# **APPLICANT'S RESPONSES TO RELEVANT REPRESENTATIONS AND ADDITIONAL SUBMISSIONS**

## **Drax Bioenergy with Carbon Capture and Storage**

**Document Reference Number: 8.3**

**Applicant: Drax Power Limited**

Ground Level Over Cross Section

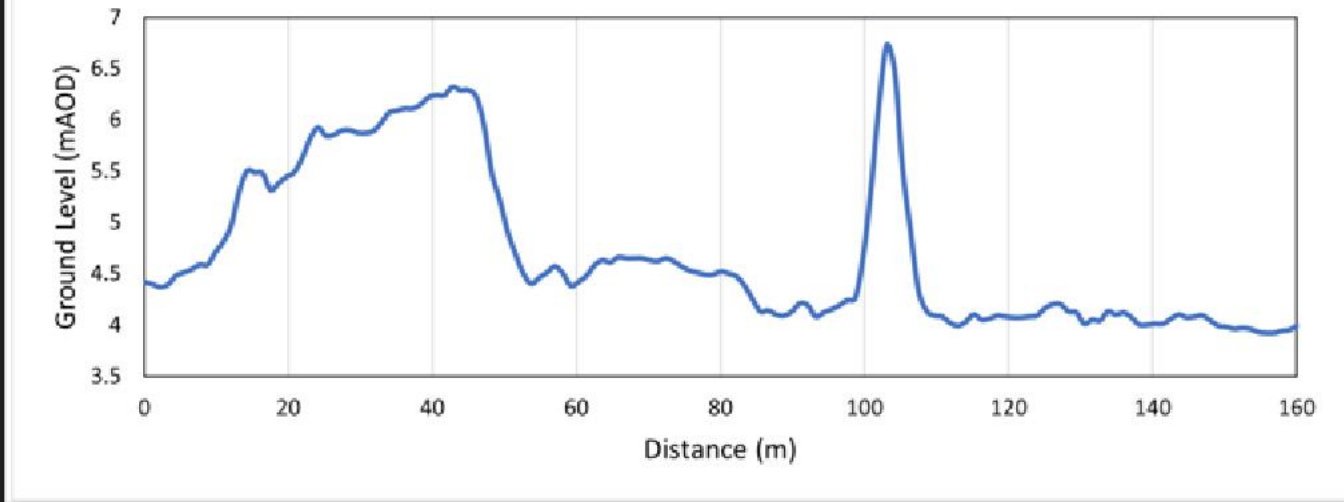
4.5	<p>Table 12.6 Surface Water Features within the study area that have the Potential to be Affected by the Proposed Scheme. Several of the ponds within this table which have a recorded presence of Great Crested Newt are not considered as 'sensitive receptor'. We disagree with this as they may be a habitat of the Great Crested Newt, which is a protected species and therefore a 'sensitive receptor'.</p> <p>This issue has also been raised in the Additional Submission Document Ref AS-040.</p>	<p>Whilst these ponds could be considered as a sensitive receptor as the presence of Great Crested Newt has been recorded / provide suitable habitat, they are not likely to be affected by the construction of the Proposed Scheme given that they are separated from the Proposed Scheme and Construction Areas, by an earth embankment, as shown in the image below, which would prevent any pollutants / contaminants which are accidentally released from the construction of the Proposed Scheme from reaching them.</p>
